**TOWN OF BAY HARBOR ISLANDS
MORRIS N. BROAD COMMUNITY CENTER
1175 95TH STREET
BAY HARBOR ISLANDS, FL 33154**

DEVELOPMENT & REVIEW COMMITTEE MEETING

AGENDA ITEM REPORT

ITEM: Review and discussion of the Site Plan Application by 9291 EBH LTD, to construct a new 32-unit multi-family development to be located at 9291-9301 East Bay Harbor Drive. Enclosed are the Site Plans and the Staff Report prepared by Town Planner, Lorrainia Belle.

Date	11-26-2025	Sheet No.
Scale		A1.01
Project	2567

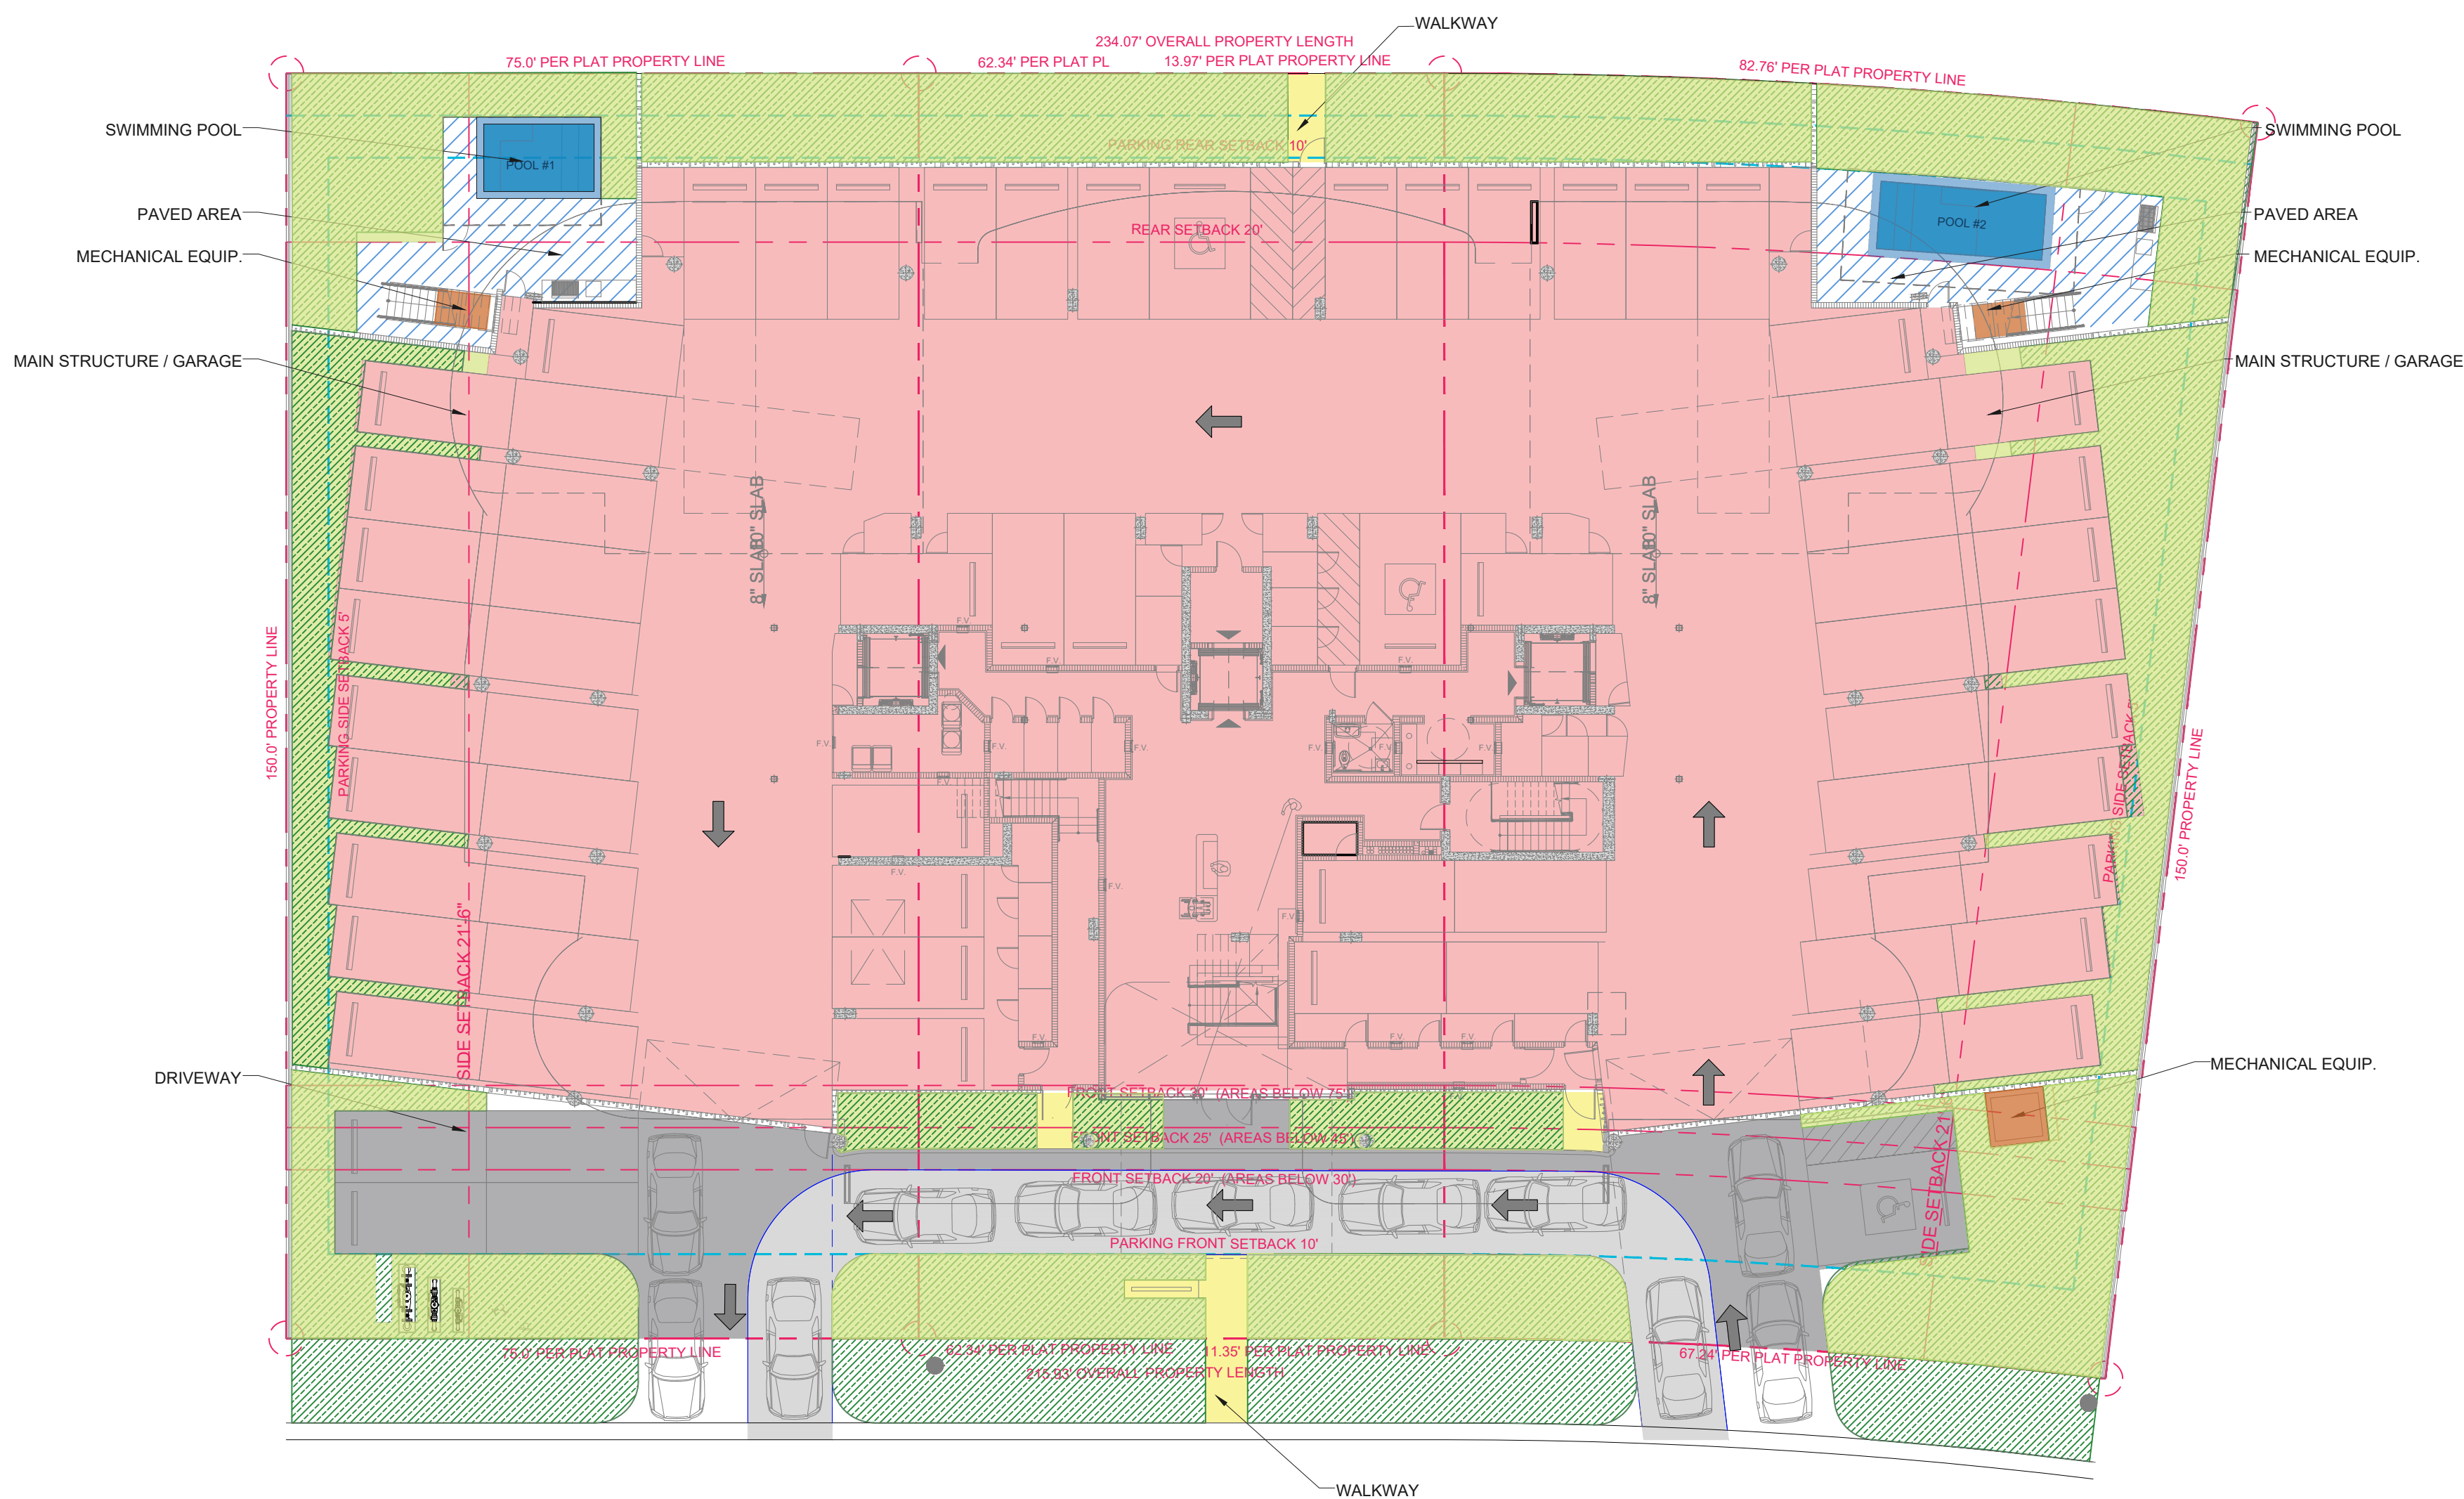
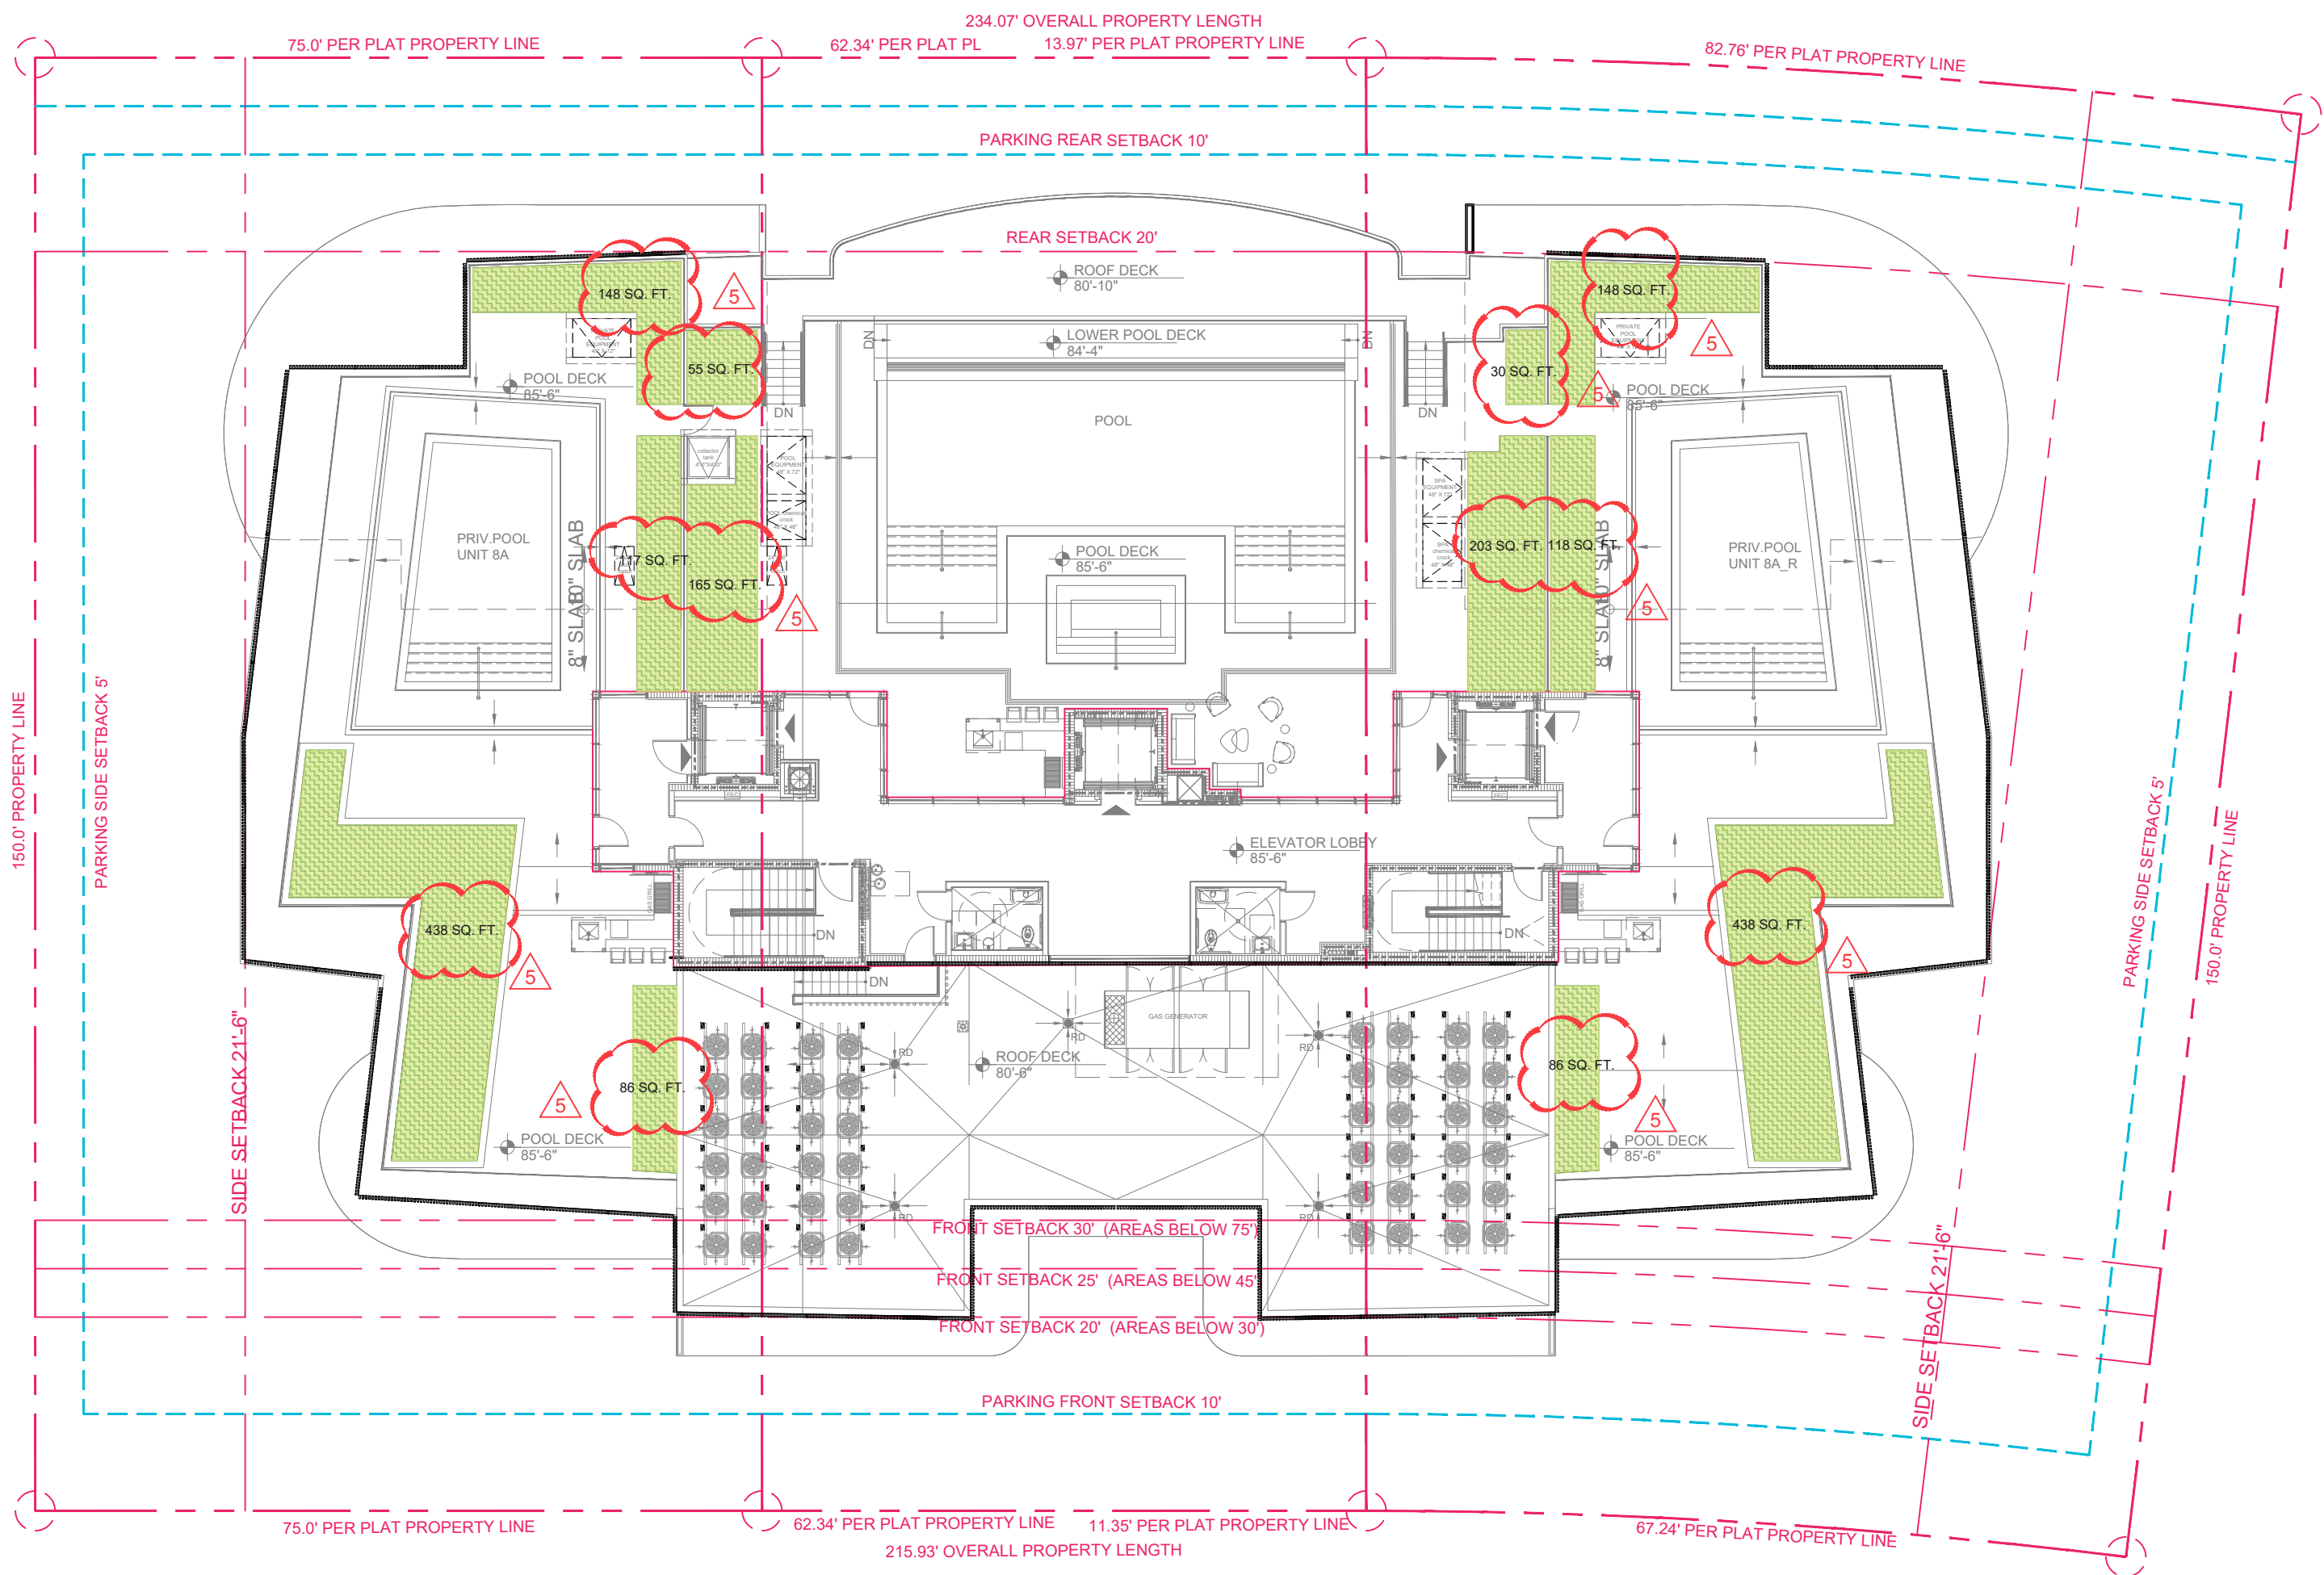
1. Provide the status of the seawall, as the building permit is expired.
2. A1.01: Make sure to add the percentage
 - a. The parking garage is 22,112 sq. ft on page A1.00 and on this page is states 20,000 sq. ft. if the garage is 22,112 sq. ft., the ground floor does not meet the 20% green space that is required.

Comment 3a: Can you please provide the square footage of each area for the rooftop.

Reply: *All square footages have been provided and enlarged for better visibility. See Page A1.01*
